## Memorandum

**SUBJECT:** **ZC 15-07 – Setdown Report** Consolidated PUD - 315 H Street NE  
(Square 777, Lots 23-28 and 813-815).

Site Plan and Building Section (Pg. A5, A9)

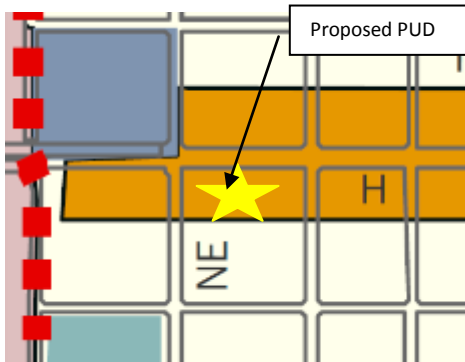
- Trash would be stored and collected from the south/rear core area of the building, which opens on to a sloped ramp leading to the 30-foot shared loading space in the “dead end” portion of public alley, not within the private property boundary.

The Applicant requests flexibility in its design to provide one 30-foot berth for residential and retail use within public alley space, not within private property bounds. A loading management plan should be provided to avoid vehicular conflicts or other alley uses from nearby properties. Additional information from the applicant and DDOT would be provided at the public hearing regarding this preference.

The proposed design does not provide the required 15-foot rear yard at the ground floor level measured from the centerline of the alley, but the requirement is satisfied at the upper floors, above 20', from the rear property boundary. Balconies are proposed within the rear yard. The loading and vehicular entry area would need to be redesigned to meet the rear yard requirement below 20'.
